Re: Amendment of Prior Approval of Development Plans and Architectural Standards for the Straits Farm subdivision, New Albany County Club Section 27, located on the west side of State Route 605 directly south of Maplewood Cemetery

This letter is to memorialize recent communications between us concerning certain architectural details for the Straits Farm subdivision. The New Albany Company previously reviewed and approved development plans and architectural standards for the subdivision pursuant to a letter dated July 15, 2013 (the "Approval Letter"). This letter is intended to amend the Approval Letter consistent with some revisions that we have recently agreed upon. These amendments are as follows:

Re: Approval of Development Plans and Architectural Standards for the Straits Farm subdivision, New Albany Country Club Section 27, located on the west side of 605 directly south of Maplewood Cemetery.

The New Albany Company has reviewed and conditionally approved the Development Plans and Architectural Standards for the Straits Farm subdivision, New Albany Country Club Section 27, as stated in Section 6 (b) of the Lot Sale and Purchase Agreement between The New Albany Company LLC, a

Plan Type B

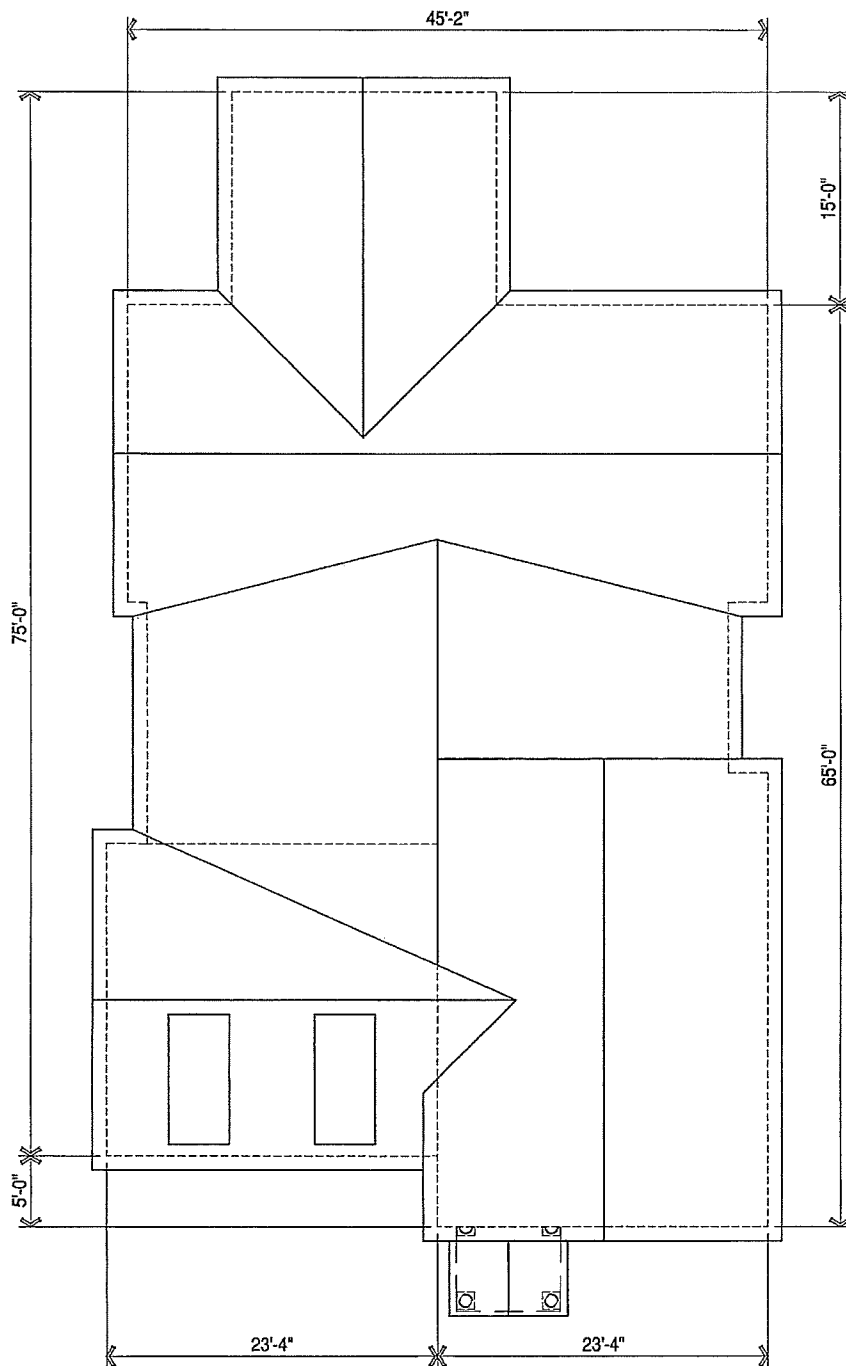
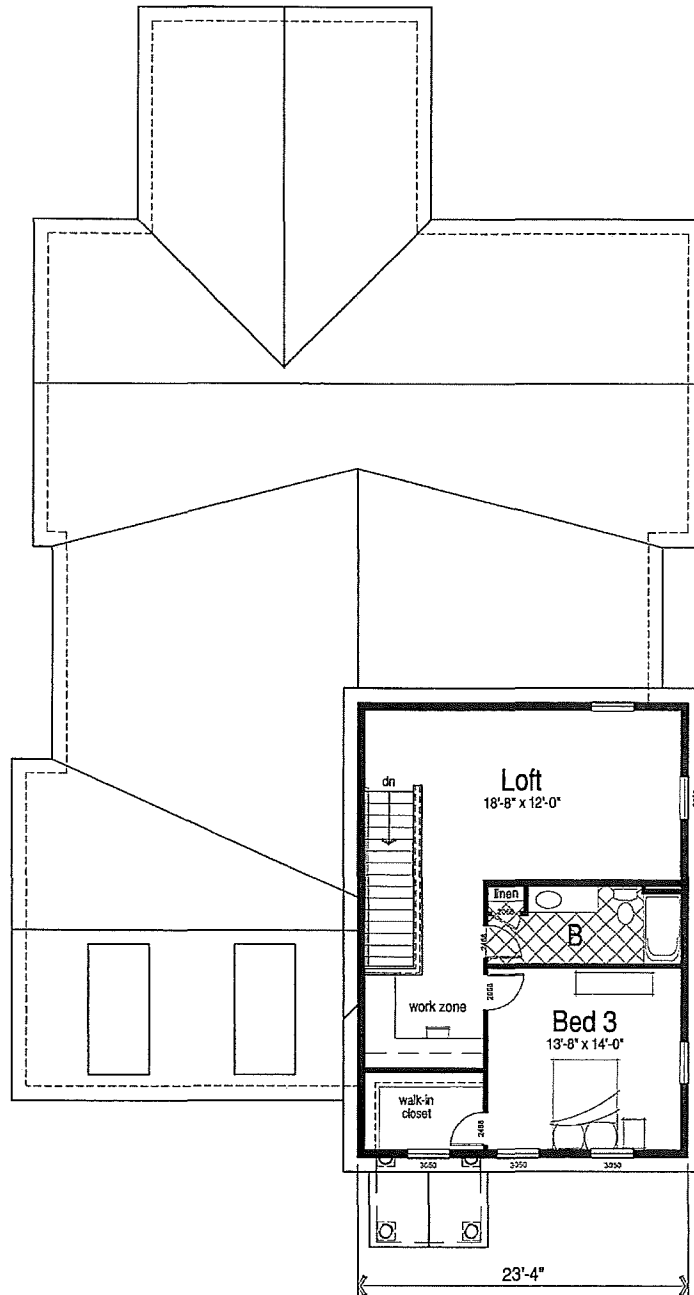
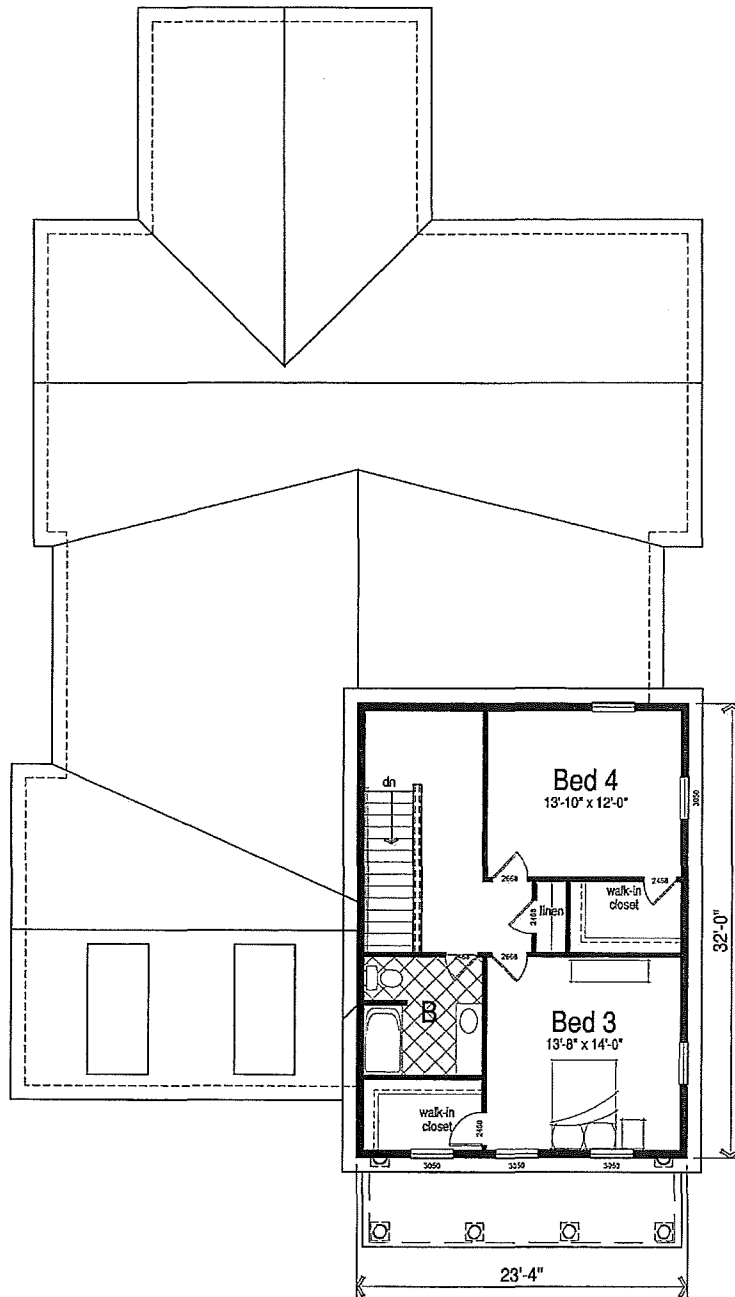
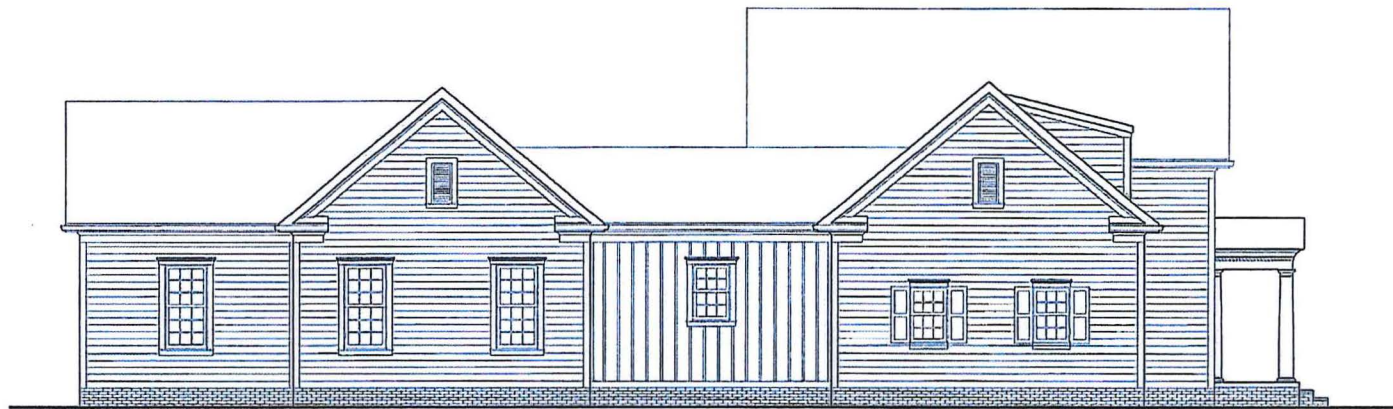
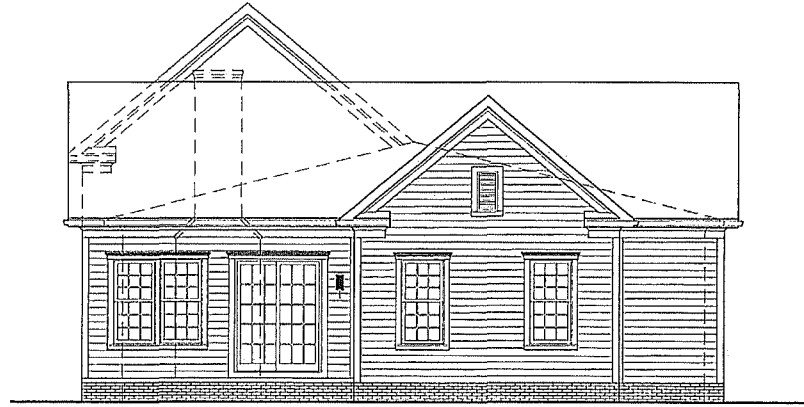
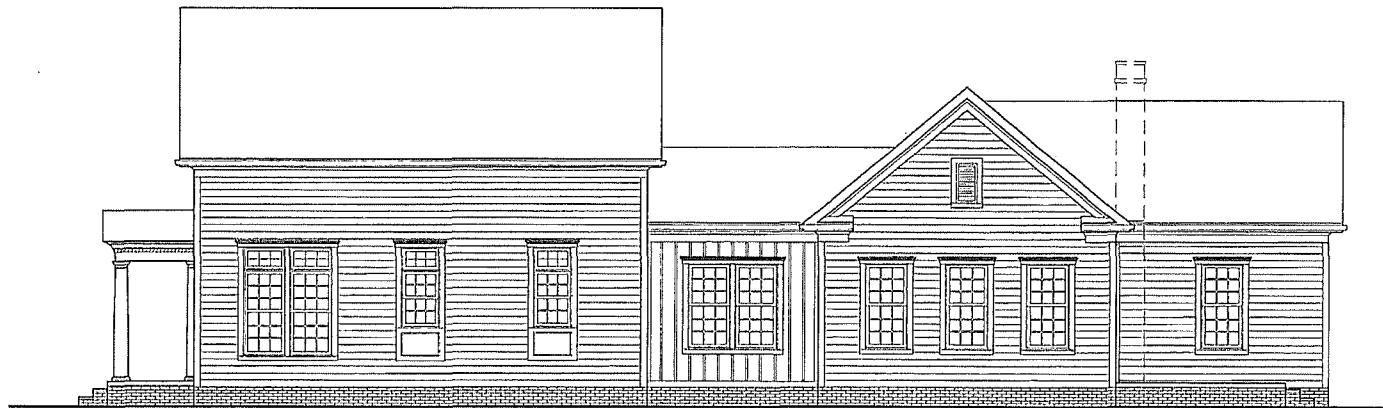
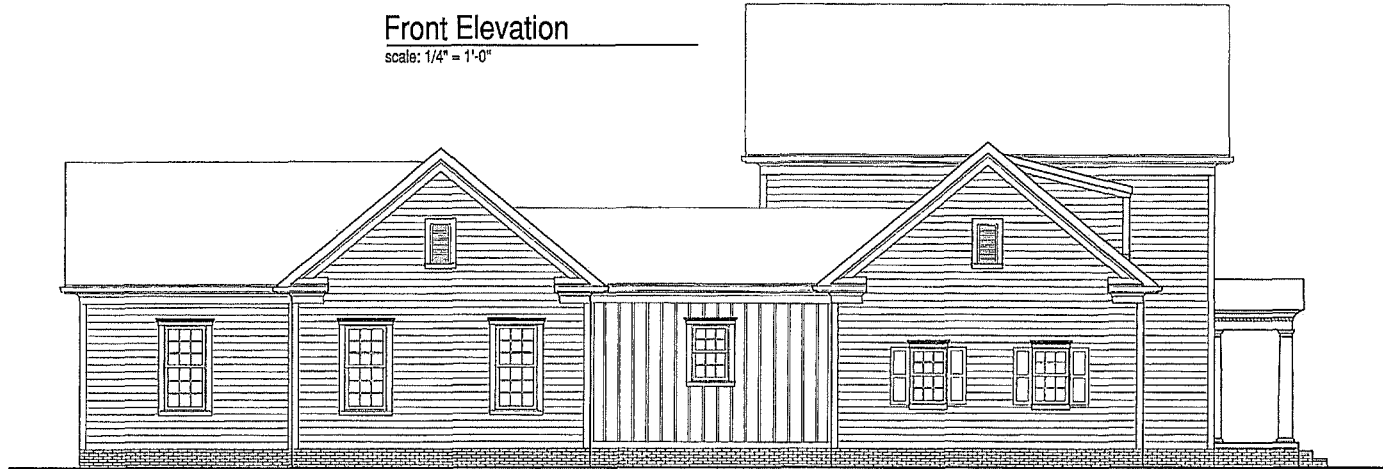
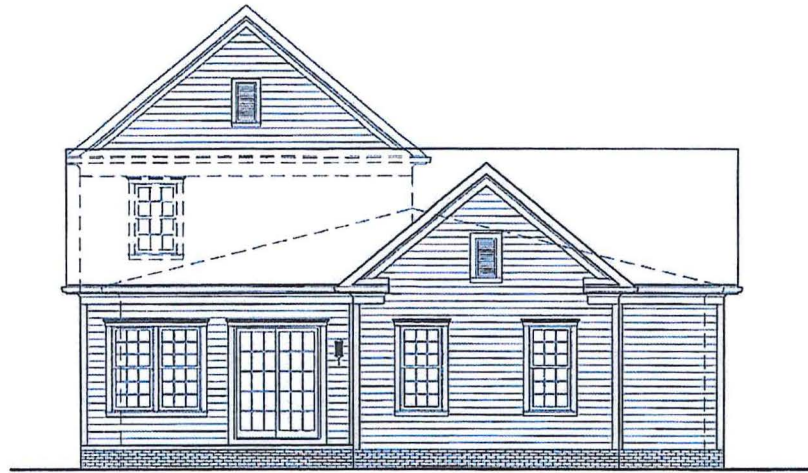
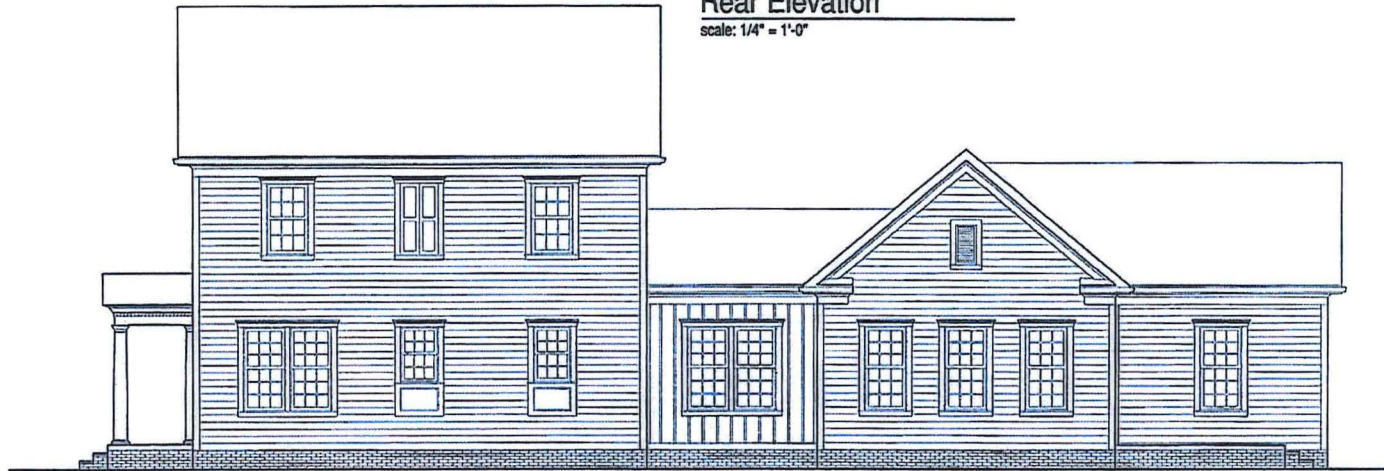
House Plan Types A, B and C, prepared by M/I Homes, dated 5.31.13, and attached hereto are approved as submitted, subject to review and approval of final architectural drawings. Detailed construction and architectural drawings are needed to review and approve items such as cornice details at the roof line, trim details around windows and garage doors, wall sections and column and entry details.

Homes fronting onto Reynoldsburg New Albany Road, lots 1, 2, 3, 4, 5, 6, 7, 8 and 9 shall be limited to only House Plan Type C.

"Homes fronting onto Reynoldsburg New Albany Road, lots 1, 2, 3, 4, 5, 6, 7, 8 and 9 shall be limited to House Plan Type A or C. House Plan Type B shall not be constructed on any of these lots."
